## **EXHIBIT 1 - STAFF REPORT**

**DATE:** September 21, 2023  
**TO:** Planning Commission Members  
**FROM:** Tom Schauer, Senior Planner  
**SUBJECT:** Continued Public Hearing – Planned Development Amendment PDA 2-23, Three Mile Lane Review TML 1-23, and Landscape Plan Review L 25-23

The applications are: Planned Development Amendment PDA 2-23, Three Mile Lane Review TML 1-23, and Landscape Plan Review L 25-23. The requests are summarized below. The applications are submitted as part of a proposal by Housing Authority of Yamhill County (HAYC) to develop a new 175-unit apartment development, “Stratus Village.” **Figure 3.**

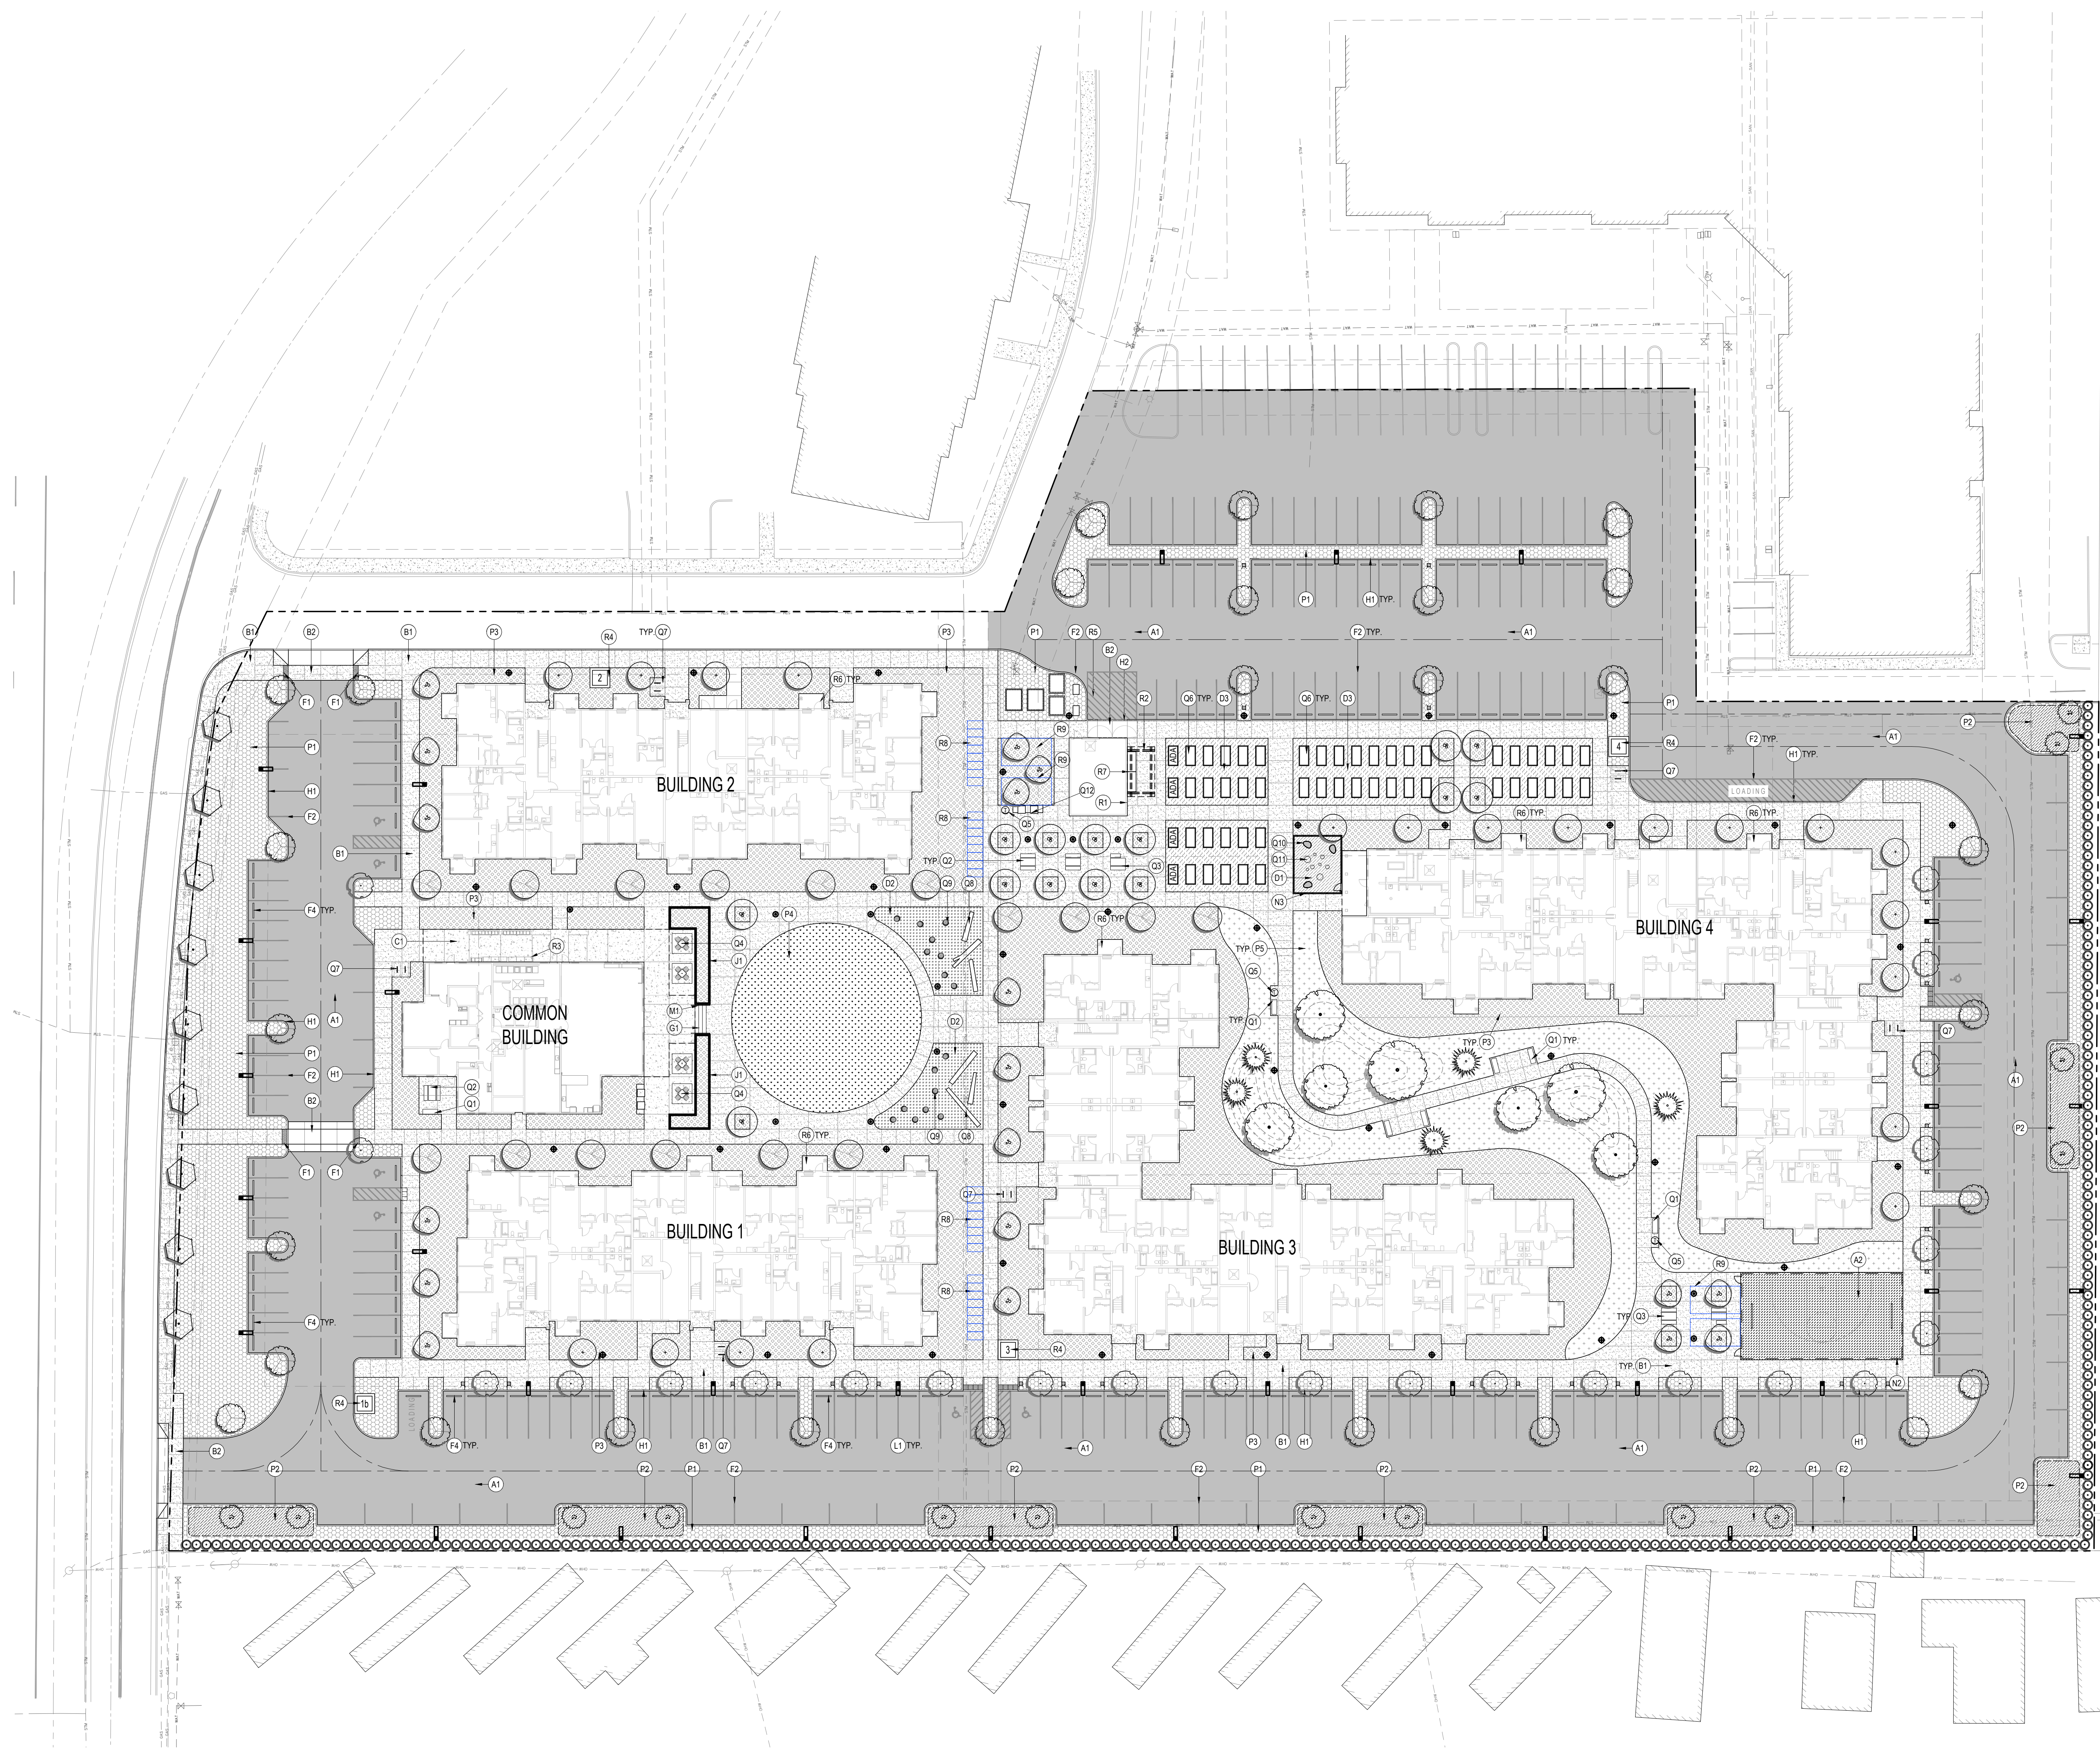
- The Zoning Ordinance has certain screening requirements. Those requirements specify that the screening can be a fence, landscaping, or a combination of the two. The applicant's original landscape plan specified a cedar fence and sight-obscuring vegetative screen. The revised proposal provides the vegetative screening, but not the fence. This complies with the applicable standards in the multi-dwelling, off-street parking, and landscaping chapters of the Zoning Ordinance. The Evergreen Mobile Home Park to the west has an existing fence along this property line, which is chain link with slats.

**APPLICANT REVISED RESPONSE:** A parking area is located adjacent to residentially-zoned (R-4) property directly to the west of this site. As a result, a landscaping buffer has been provided along this length of the property. Details on the plantings within the parking area can be found on Sheet L1.00, Materials Plan. Living material will be installed that meets the objective standard for site obscuring.

**APPLICANT RESPONSE:** A parking area is located adjacent to residentially-zoned (R-4) property directly to the west of this site. In response to this, a series of 'Green Giant' Arborvitae (*Thuja plicata* 'Green

Giant') will be planted along the Western property line. This arborvitae will be planted at an 8-foot on-center planting density, creating a dense, evergreen hedge that will meet the screening requirements of this section. The arborvitae will reach a height of 8 feet--adequate to screen the parking area. This screening material at the same planting density will be continued around the Southern perimeter of the site, creating a cohesive, dense, green hedge.

SHEET NUMBER  
**L5.00**

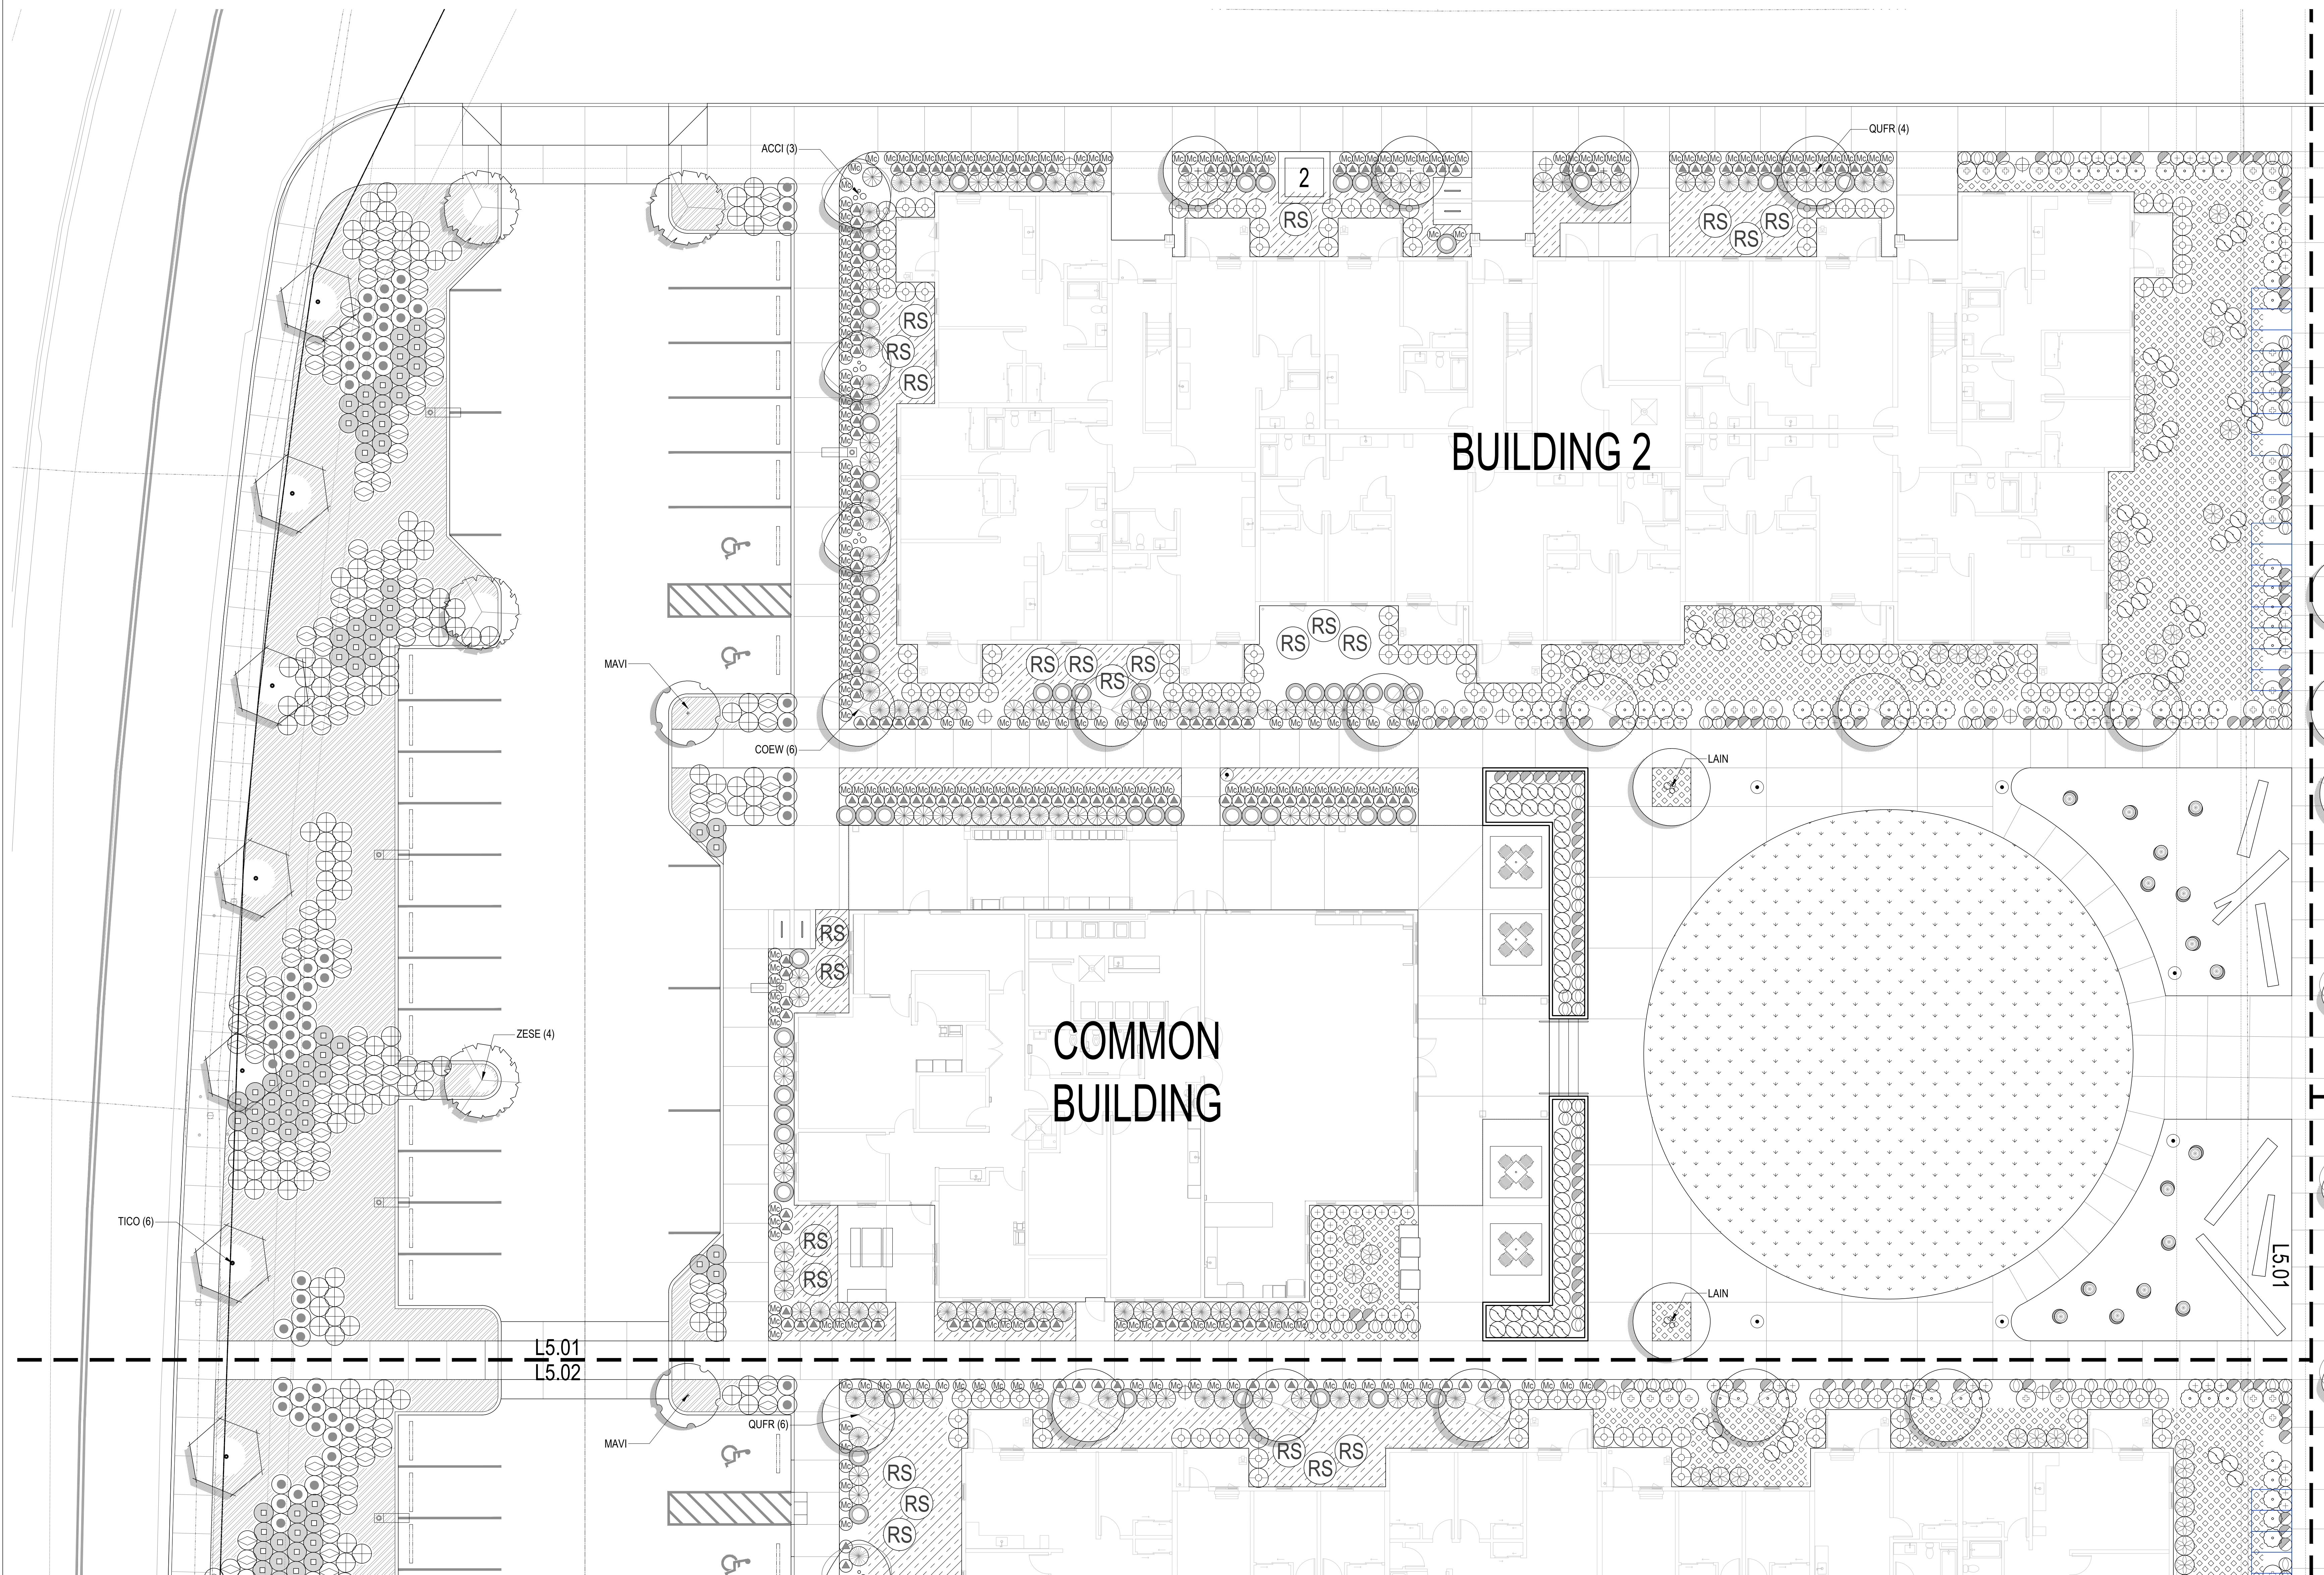
- The original landscape plan also showed a mix of plantings in certain areas without showing the details of the individual plantings within those areas. The new landscape plan provides those details. At the August 17 meeting, Commissioners had questions about the privacy of the ground floor patios. This planting plan shows the types of plantings around these patios, providing the types of plantings described in the multi-dwelling standards for privacy and delineation of private spaces.

- The revised landscape plan shows bike racks, bike lockers, and covered bike shelters as follows:
  - Legend Q7: Bike Racks, with five locations provided – one location near each building central entrance. These are the same or similar locations shown on the original plan.

- Legend R8: Bike Lockers, with 16 south of Building 1 and 16 south of Building 2 shown (noted as “preliminary locations, see spec”). These were not on the original plan.
- Legend R9: Bike Shelters, with 2 shown north of the sport court and 2 shown north of the trash enclosure (noted as “preliminary locations, see spec”). These were not on the original plan.

The bike racks (Q7) are proposed as part of the plan and were shown in the same general locations on the original plan. The bike lockers (R8) and bike shelters (R9) shown on the revised landscape plan **are not proposed at this time**. However, the applicant is continuing to study the best amount and location of bike parking. The information shown on the plan reflects their current study of bike parking options. The applicant will likely install some additional bike facilities currently under consideration. Once they have made that decision, they intend to request Planning Director approval for a minor amendment.

**Figure 2. Approximate location of parking easement on HAYC property benefiting Altimus Plaza**

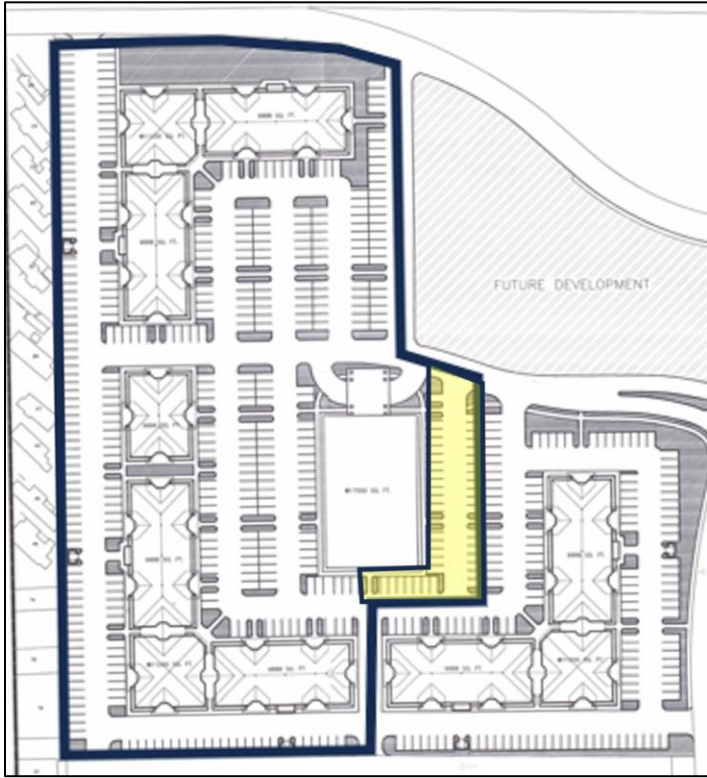
As part of the Planned Development application, the applicant, Housing Authority of Yamhill County (HAYC), has requested flexibility regarding standard (f)(3) as it relates to parking along the east property line, where existing parking was previously developed in a shared configuration prior to these standards, with parking spaces abutting each side of the easterly property line. **See Figures 1 and 2.** Adjacent to other property lines where there is not a common parking area, the applicant's plan maintains 10 feet between the parking spaces and the property lines.

**Figure 3** shows an enlargement of the site plan. Please note that the site plan includes a continuous 5-foot wide row of north-south landscaping with shrubs in the easterly parking area, separating the easterly parking aisle on the HAYC property that is subject to the easement from the westerly aisle that isn't subject to the easement.
